* Red text denotes Approved plans to be modified by this application (Stage 2B - Building D and E)

Project
AQUA
STAGE 2B - Building D & E
Panthers North Precinct, Penrith
Sydney NSW Australia

SECTION 4.55
Drawing Title

S4.55 SCHEDULE OF AMENDMENTS
Basement:

FLOOR PLANS
Drawing Title
LEVEL 04 FLOOR PLAN

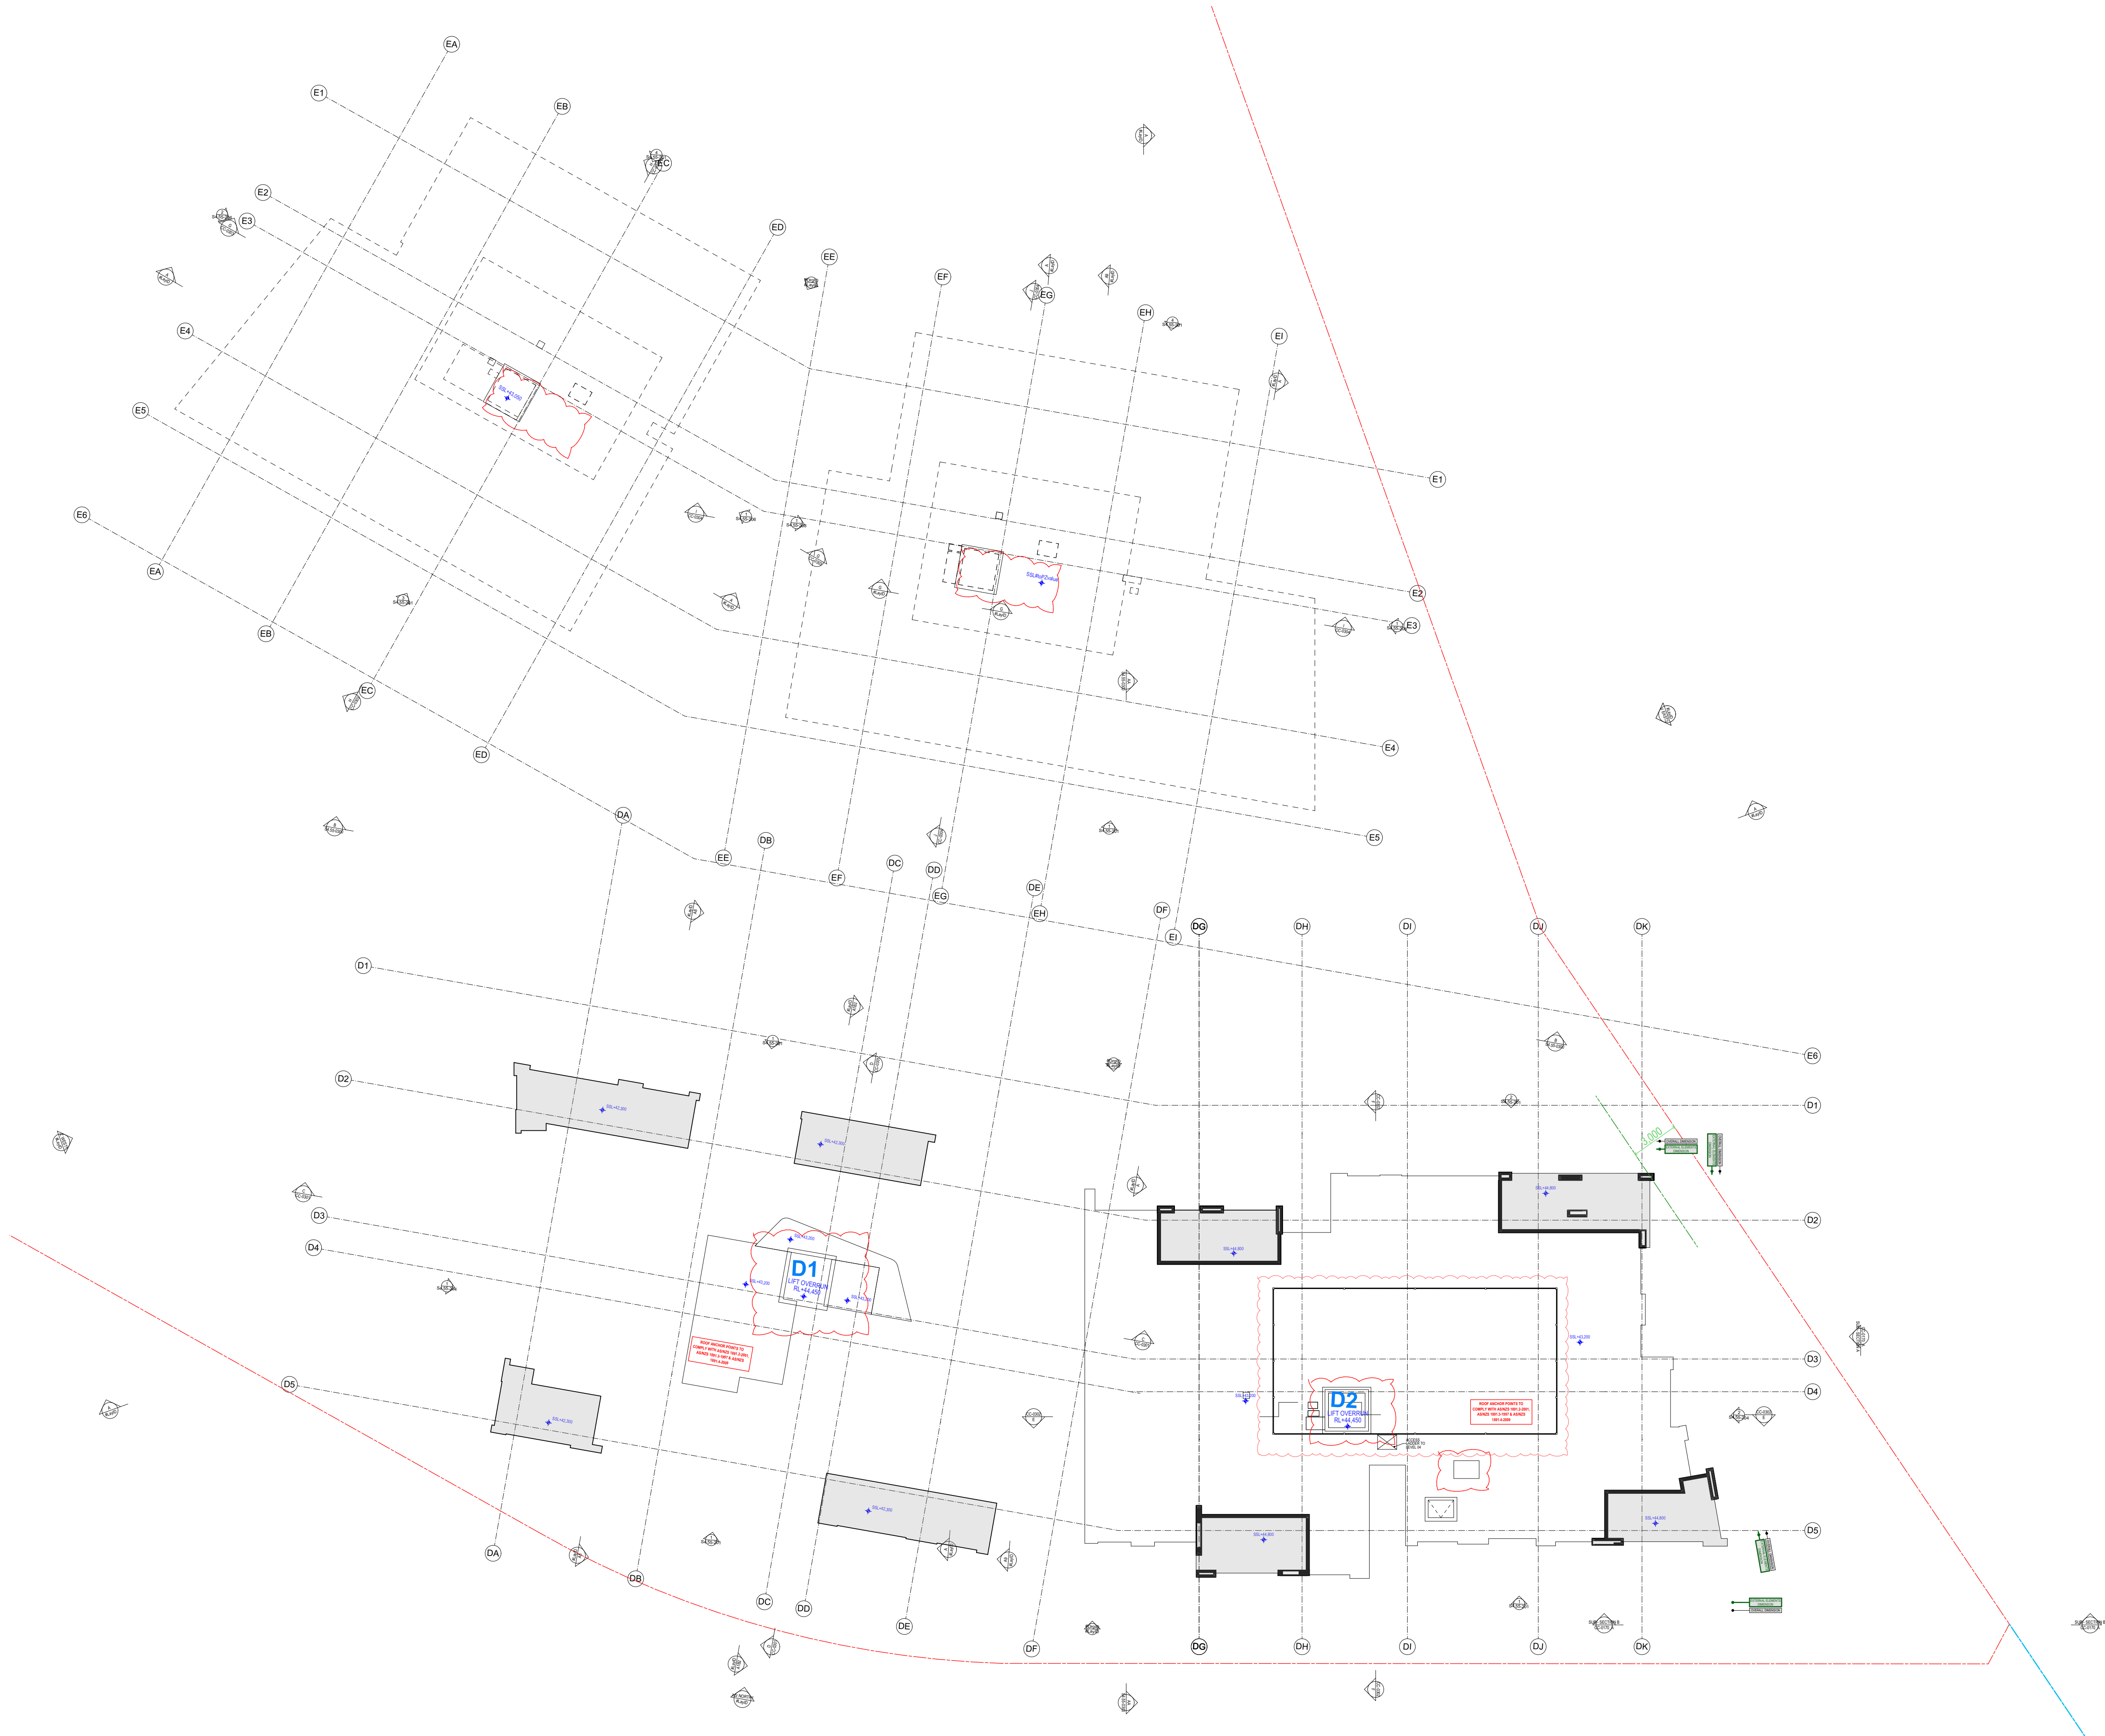
S4.55 SCHEDULE OF AMENDMENTS
Level 04:

- Inclusion of adaptable units
- Building D West lowered RL 41,000 to 40,300
- Building D East raised RL 39,650 to 40,050
- Building E raised RL 39,450 to 40,350
- skylight added to D.507

ELEVATIONS
Drawing Title
ELEVATIONS BLDG D

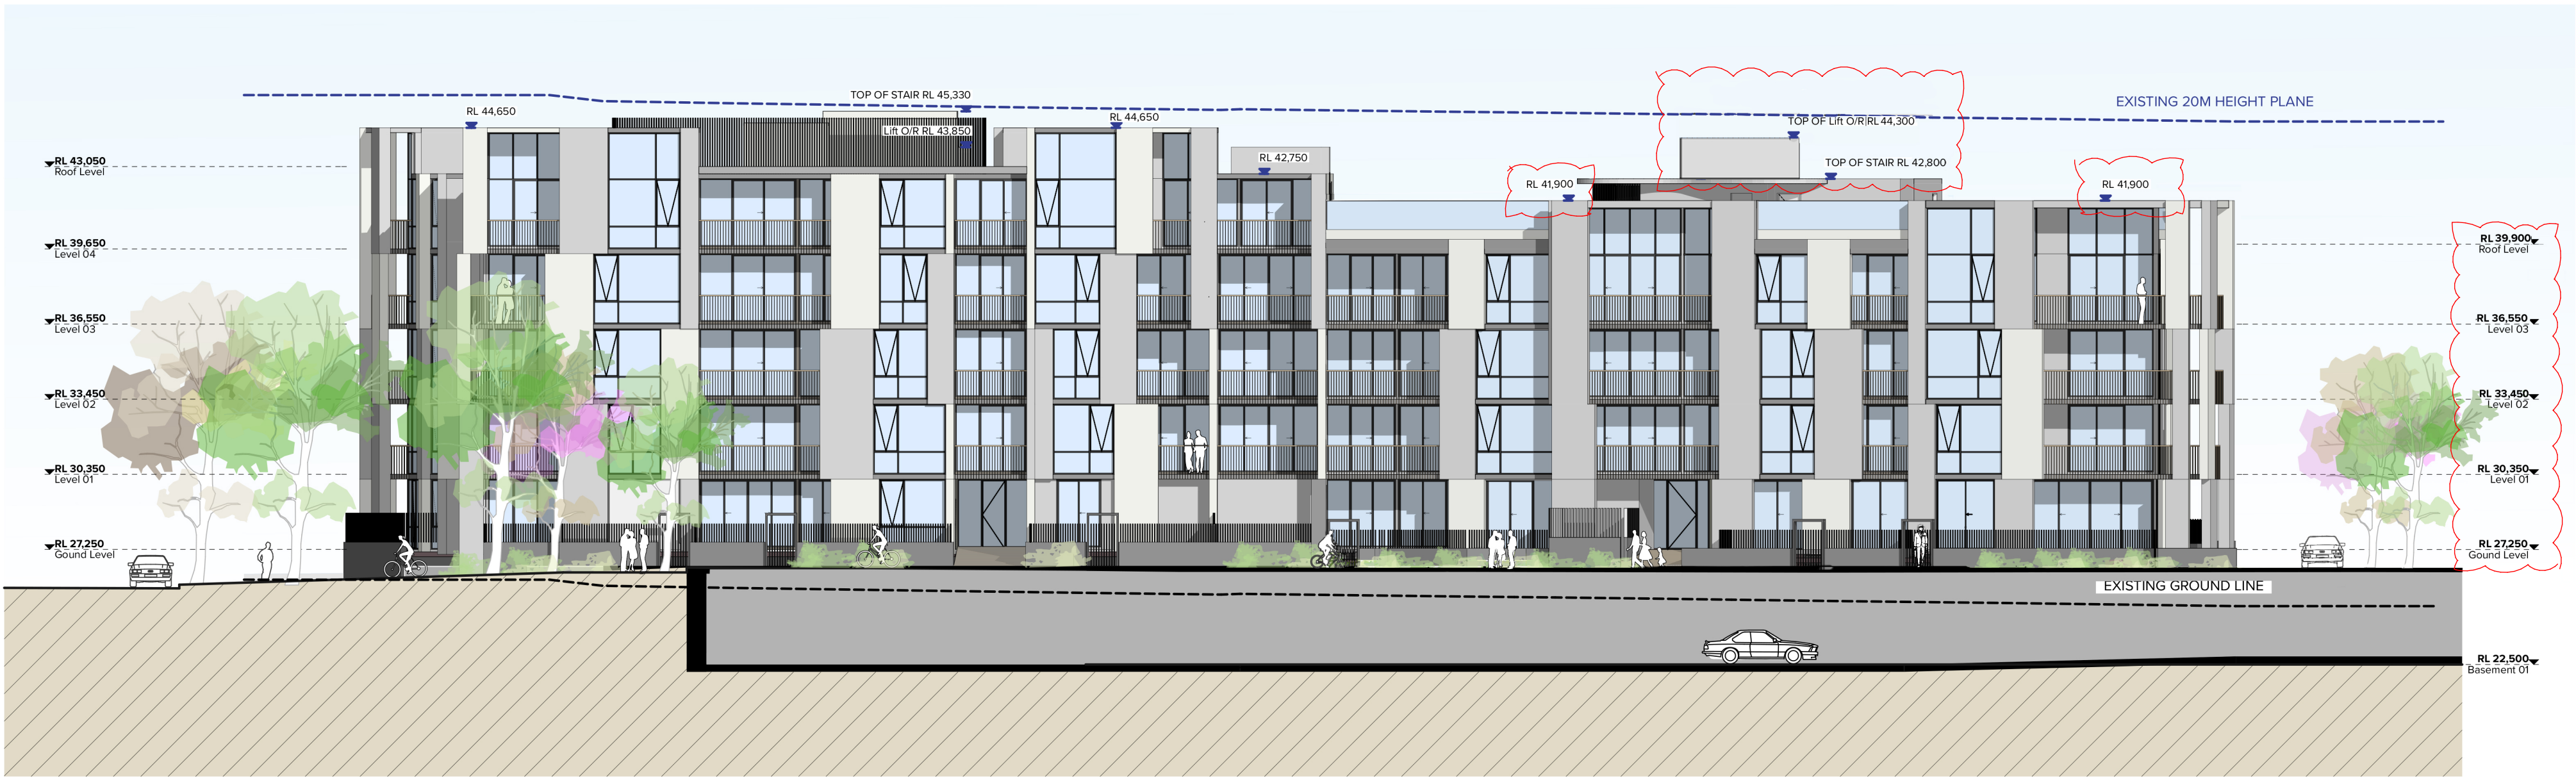
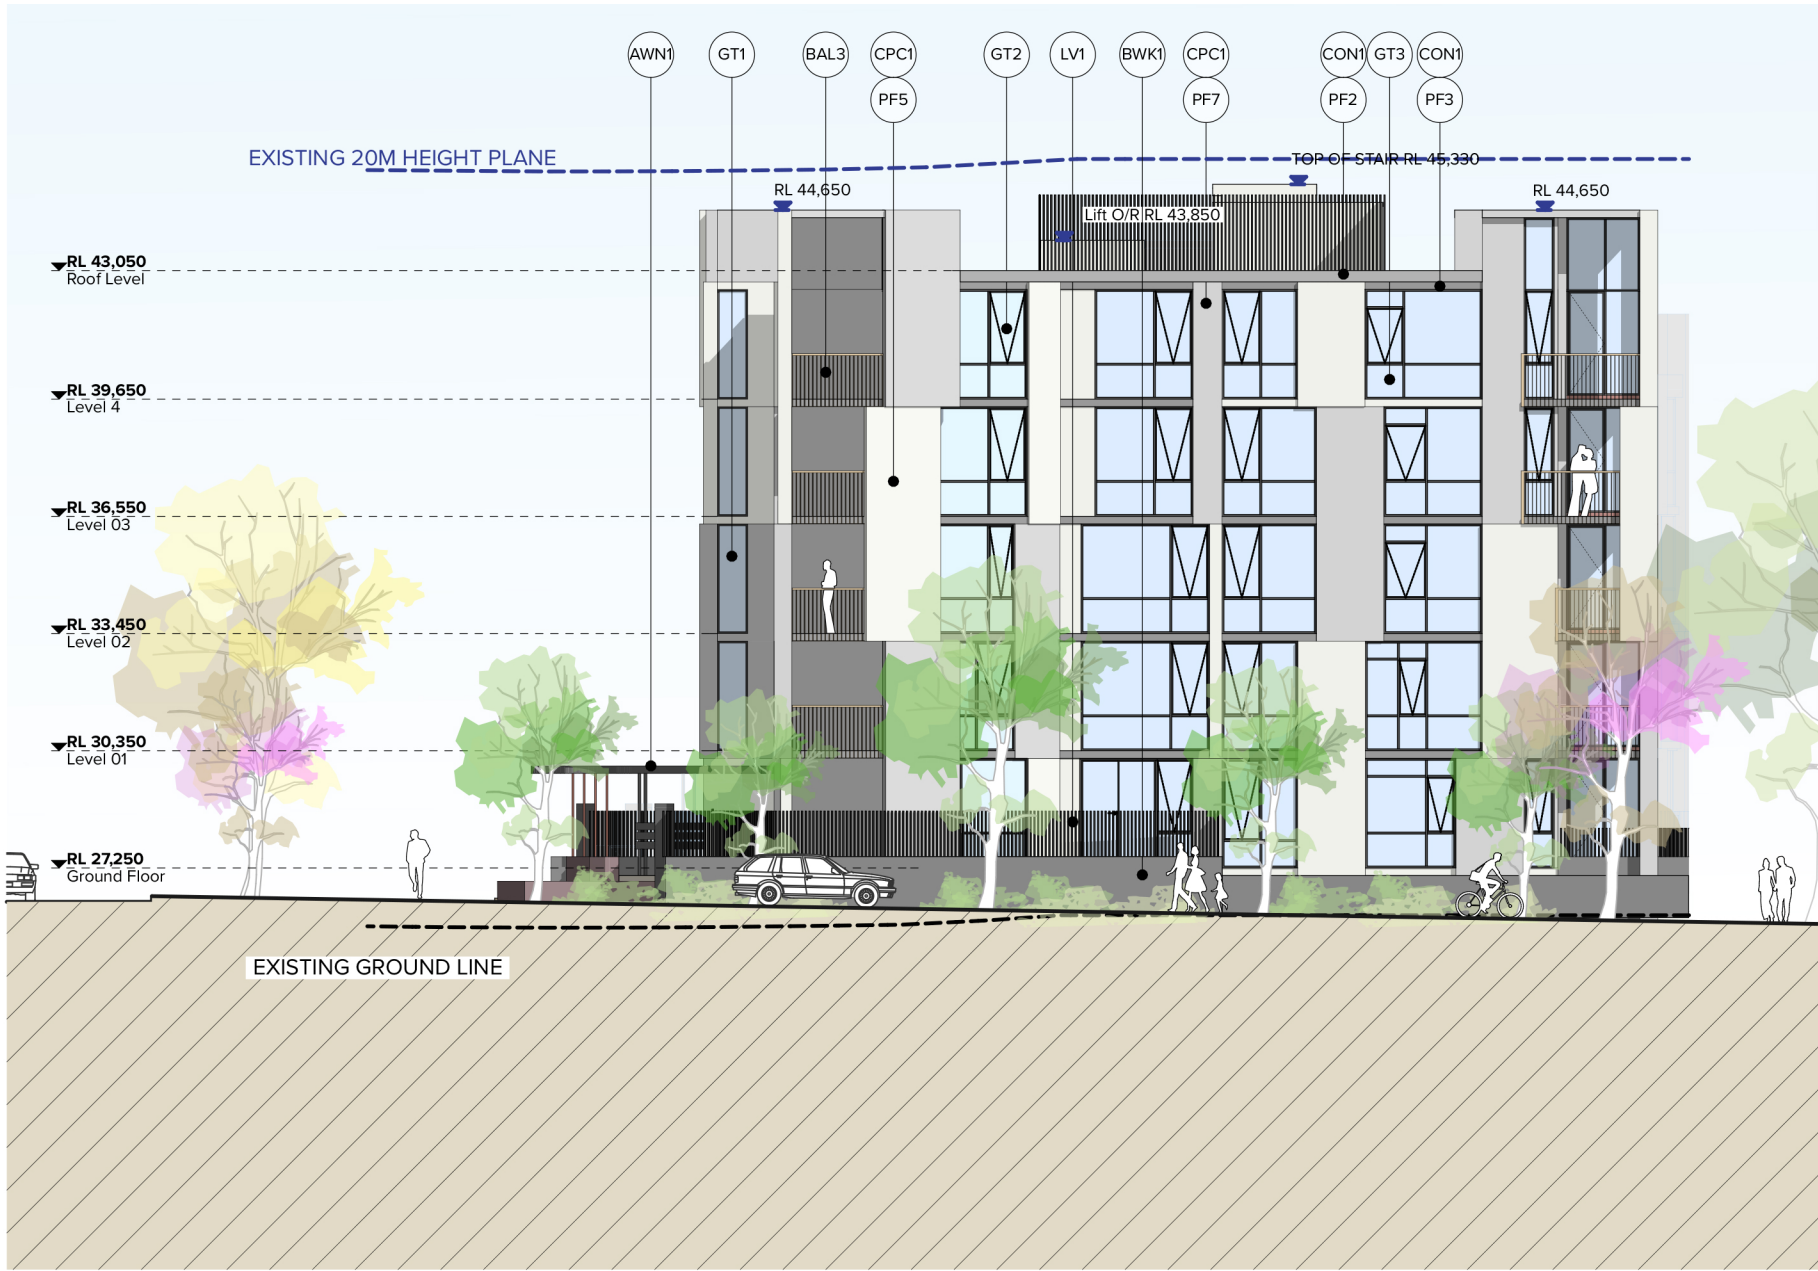
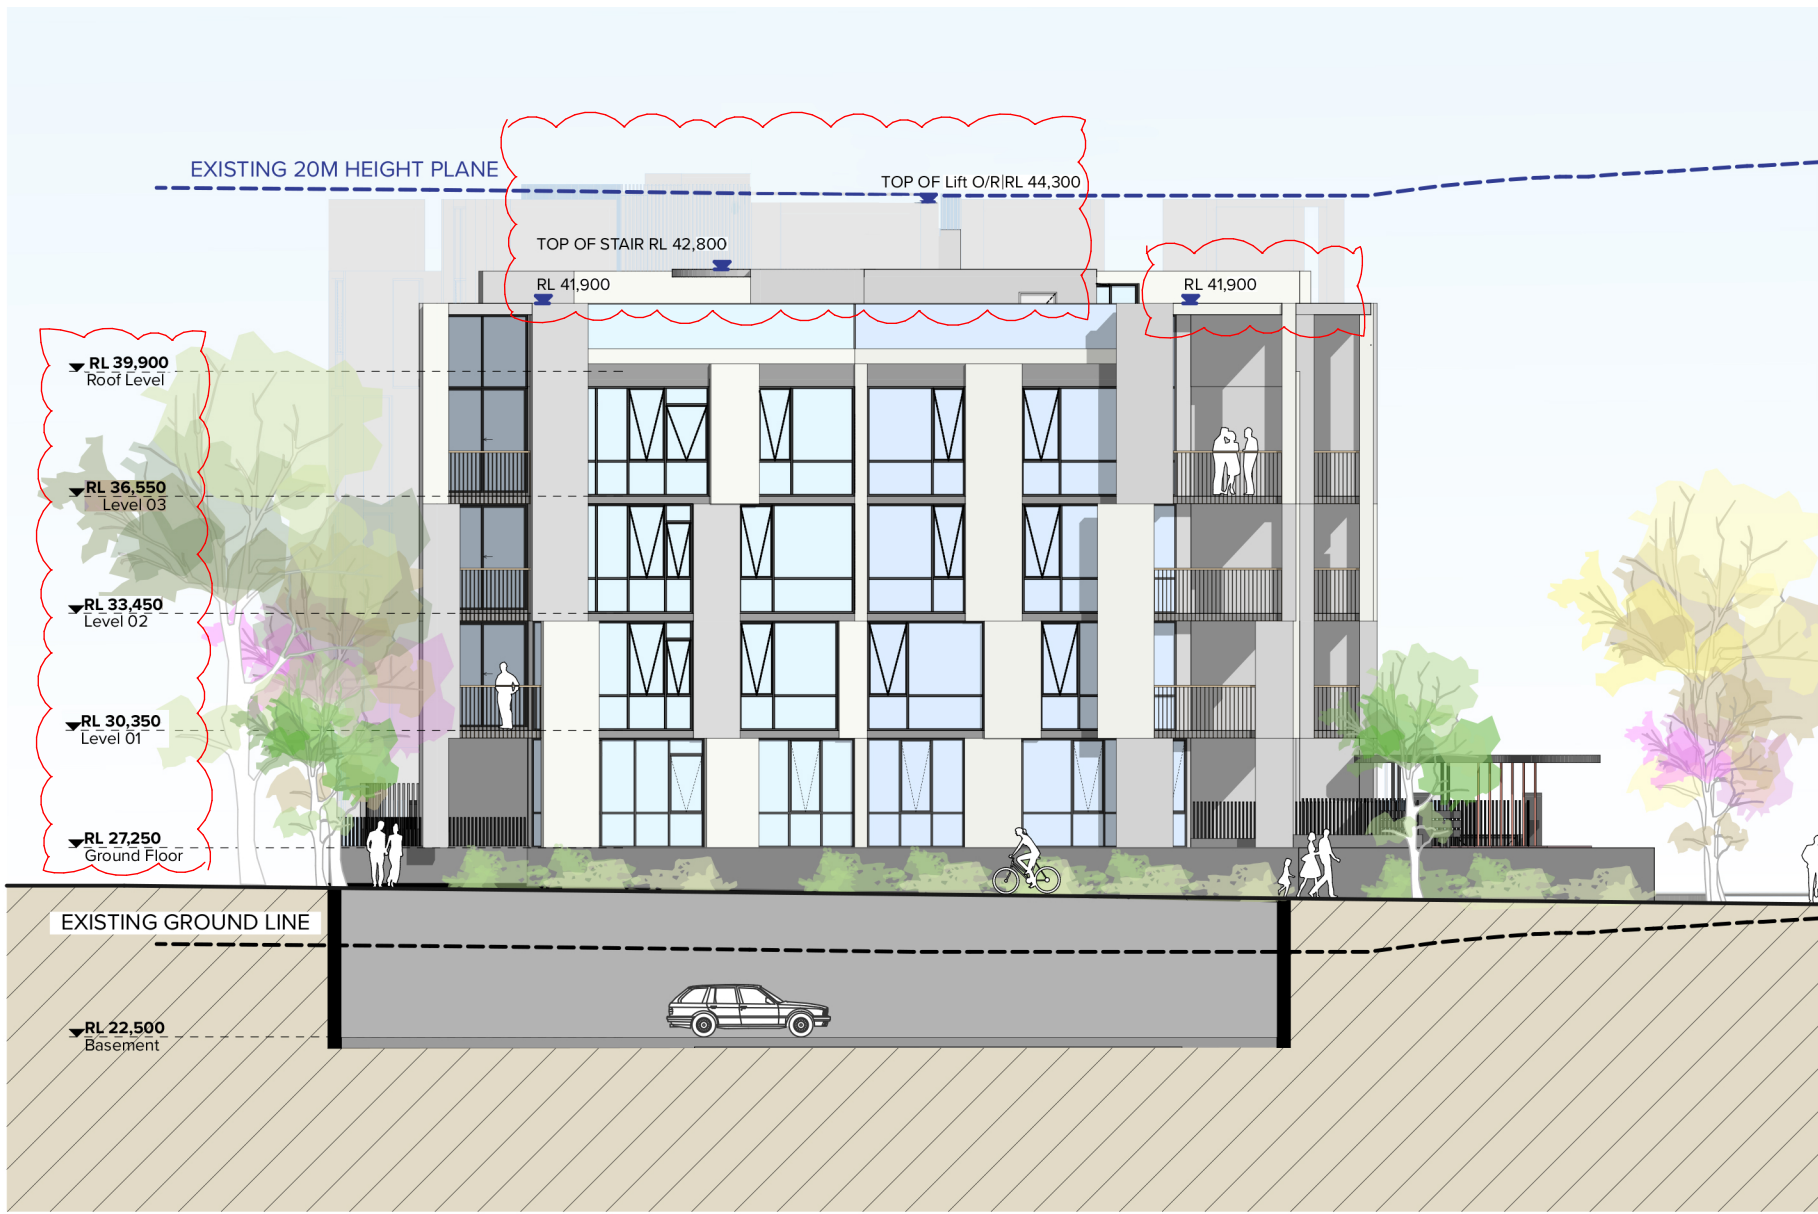
**S4.55 SCHEDULE OF
AMENDMENTS
Elevations:**

- building D west RLs lowered to match building D east
- lift over-run increased levels
